REVISION NOTES

BUILDING D - PHYSICAL EDUCATION
COLLEGE OF SAN MATEO
SAN BRUNO CALIFORNIA

DATE		JOB NO.
11-8-67	JOHN CARL WARNECKE AND ASSOCIATES	1804
DRAWN	ARCHITECTS AND PLANNING CONSULTANTS	DWG NO.
H.H.	61 NEW MONTGOMERY ST. - SAN FRANCISCO	SD102

DSD102

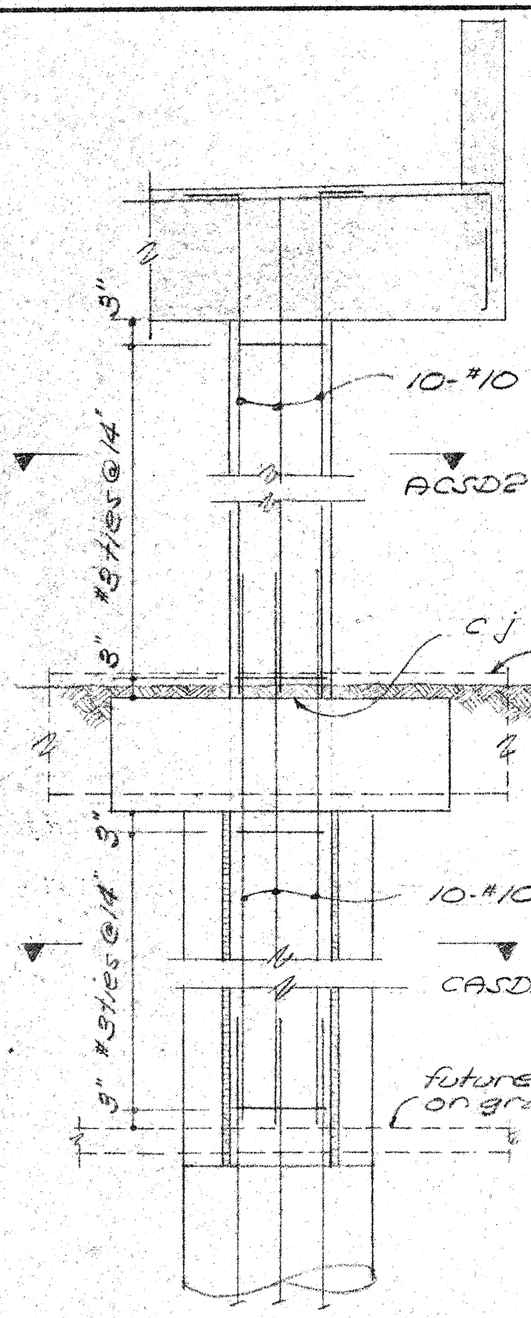
For bal & details not shown see ASD2

ASD2 REVISED

BSD102

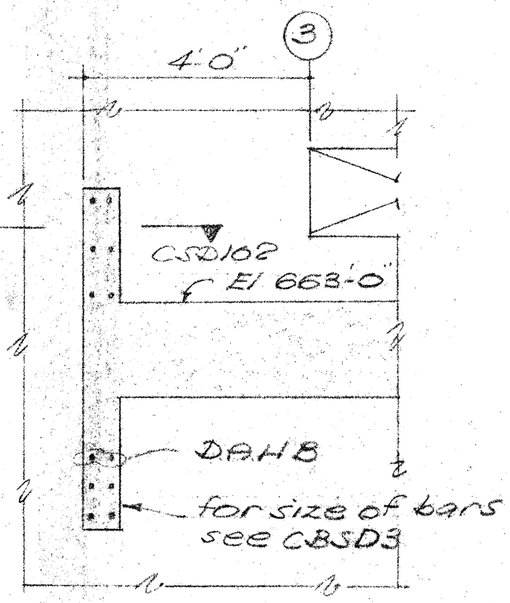
For bal & details not shown see CASD11

CASD11 REVISED

At CASD11 change dimension at top of panel at line (1) from "1'-0 1/2" to "1'-2 1/2" "

ASD102

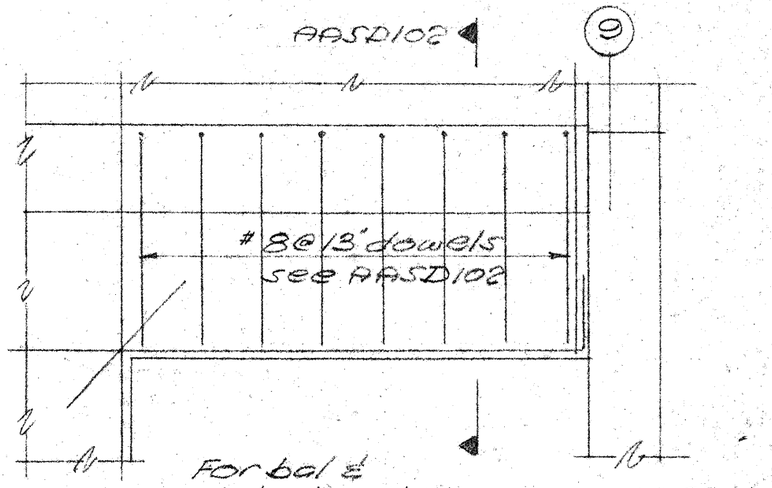
For bal & details not shown see AASD11

AASD11 REVISED

At AASD11 change overall dimension of wall from "23'-4 3/4" " to "24'-5 3/4" ".

AASD102

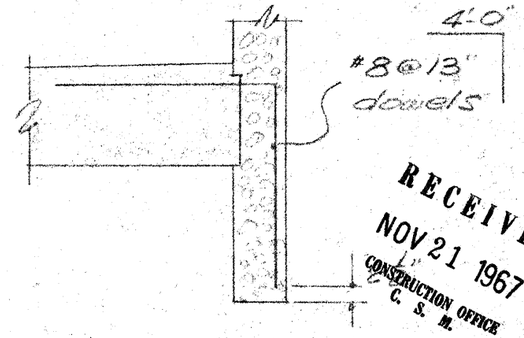
For bal. & details not shown see DSD12

DSD12 REVISED
